NRC-03-108

November 5, 2003

**KEWAUNEE NUCLEAR POWER PLANT  
DOCKET 50-305  
LICENSE No. DPR-43  
RESPONSES TO REQUESTS FOR ADDITIONAL INFORMATION AND  
SUPPLEMENTAL INFORMATION REGARDING LICENSE AMENDMENT REQUEST  
195, STRETCH POWER UPRATE FOR KEWAUNEE NUCLEAR POWER PLANT**

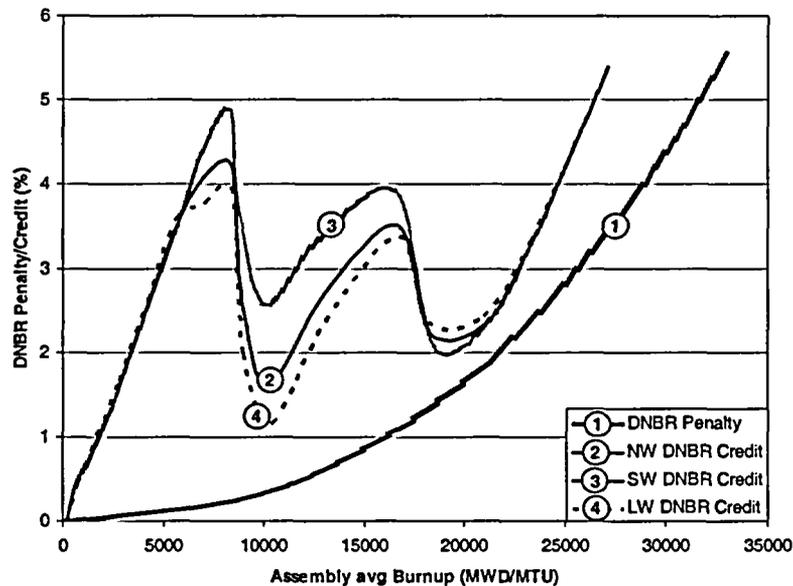
- a. **The RTSR analyses included a 2.6 percent rod bow DNBR penalty. For the stretch uprate, the licensee reduces the rod bow penalty from 2.6 percent to 0 percent for Cycle 26 by evaluating the F H burndown DNBR credit during the entire cycle. Please provide the technical justification for this change in the rod bow penalty. Include descriptions of the F H burndown DNBR credit and the analyses performed to quantify F H burndown DNBR credit, and provide a reference to the NRC-approved methodology applied. Also, provide the results of the analyses which demonstrate that the necessary rod bow penalty is offset by the F H burndown DNBR credit for Cycle 26.**

The 2.6% rod bow DNBR penalty is based on an analysis performed in Refs. 1 and 2 where it was demonstrated that credit for FdH burndown can be used after 24,000 MWD/MTU (assembly average burnup) to limit the rod bow DNBR penalty to 2.6 % for 0.422 OD diameter fuel and WRB-1 DNB correlation. Beyond 24,000 MWD/MTU the rod bow penalty increases beyond 2.6% but it was shown that for a representative set of cycles using Westinghouse fuel, the FdH burndown conservatively offset the additional DNBR penalty and therefore a 2.6% rod bow DNBR penalty is acceptable. This is the general approach that does not require any cycle specific analysis. The method used to evaluate the rod bow DNBR penalty for Kewaunee Cycle 26 was as analogous to the method used for Ref. 1. However, the analysis was performed using the peak FdH as a function of assembly burnup for the specific cycle only (long, normal and short EOC 25 windows). BOL conditions set the reference for the rod bow DNBR penalty (0%) and the FdH burndown credit (0%). The rod bow DNBR penalty increase with assembly average burnup was calculated according to the approved methodology described in Ref. 1. The peak FdH as a function of assembly burnup was calculated by ANC for Kewaunee Cycle 26 (long, normal and short windows). The credit/penalty curves due to FdH variation were calculated based on a conservative one-to-one relation with DNBR (this is much less than the minimum DNBR sensitivity to FdH, which is calculated to be 1.898 for the set of RTDP conditions used in the Design Limit DNBR calculation). The result of the comparison is shown below.

The figure shows that the rod bow DNBR penalty is offset by a conservative FdH burndown credit over the entire life of Kewaunee Cycle 26 core. Therefore the rod bow DNBR penalty was evaluated to be 0% for Kewaunee cycle 26. Please note that even though a similar methodology as the one used in the approved topical report (Ref. 1) was used, since the analysis was performed based on Kewaunee Cycle 26 peak FdH only, this is in non conformance with the current approved methodology and therefore needs a specific approval for use during this cycle.
